# UNITED STATES PATENT AND TRADEMARK OFFICE

**Office Action Summary**

10/728,753

MURATA, SHIGERU

**5,261,798**

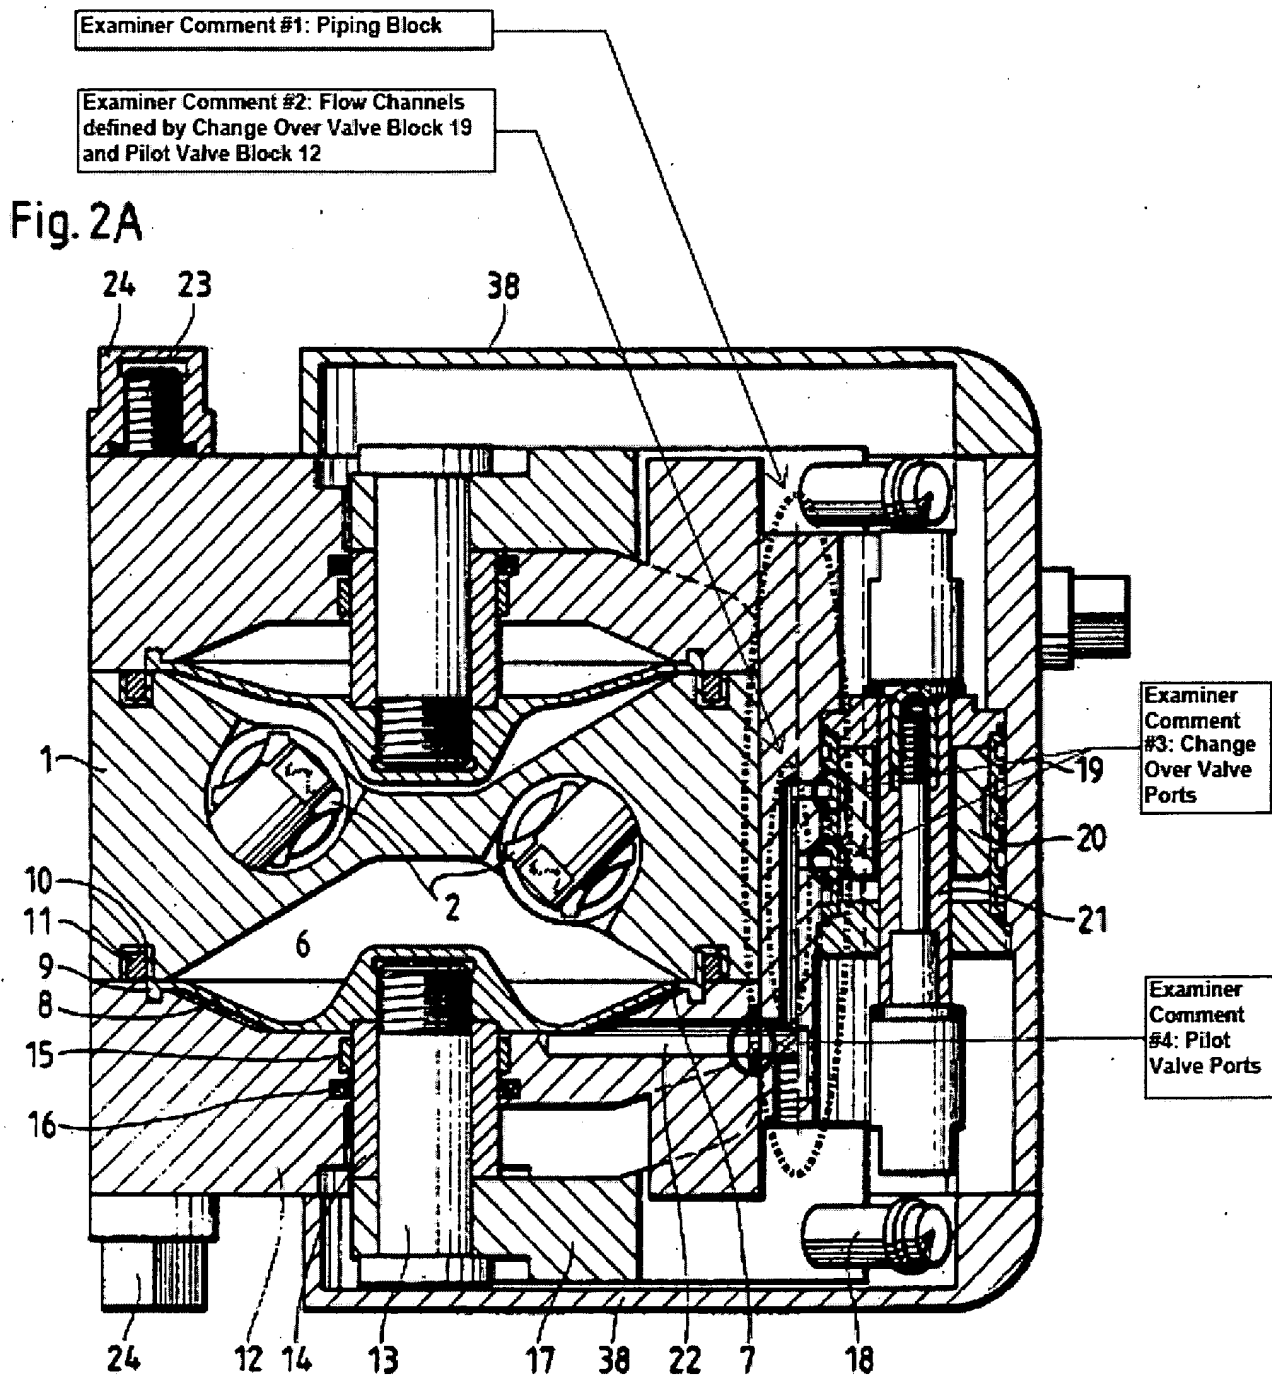
Claims 1-4 rejected under 35 U.S.C. 102(b) as being anticipated by Budde 5,261,798. Budde teaches all the limitations of the invention as substantially claimed for a reciprocating fluid transfer pump including: a fluid once having suctioned into a fluid delivering chamber 6 is discharged by expanding and contracting a barrier membrane 7 attached to an end portion of a

center rod 13 capable of making a reciprocating movement relative to a main body block 1 and defining said fluid delivering chamber 6 and a driving chamber 8, a peripheral portion of said barrier membrane 7 is clamped and thus secured fixedly to said main body block 1 via a main ring 9 and a sub ring 10, and a pilot valve assembly block 12 having a pilot valve 22, operated via 17, integrated therein as one body for detecting a reciprocating motion of said center rod 13 is pressed against and thus secured fixedly to said main body block 1 with the aid of said main ring 9 and said sub ring 10; a change-over valve assembly block 19 having a change-over valve 20 integrated therein as one body for switching movable directions of said center rod 13 (col. 4 ll. 22-30) is secured fixedly to said main body block 1, wherein said change-over valve assembly block 19 and said pilot valve assembly block 12 are interconnected via a piping block (comment #1 on Fig. 2A) defining flow channels (comment #2 on Fig. 2A) for connecting change-over valve ports (comment #3 on Fig. 2A) with pilot valve ports (comment #4 on Fig. 2A); change-over valve ports (comment #3 on Fig. 2A) and pilot valve ports (comment #4 on Fig. 2A) connected to flow channels (comment #2 on Fig. 2A) of a piping block via connectors, via 17 and 18; and a piping block (comment #1 on Fig. 2A) secured fixedly to the main body block 1 via the pilot valve assembly block 12, via 12 and 38. Reference is made to Figure 2A of Budde, included subsequent to paragraph 6.
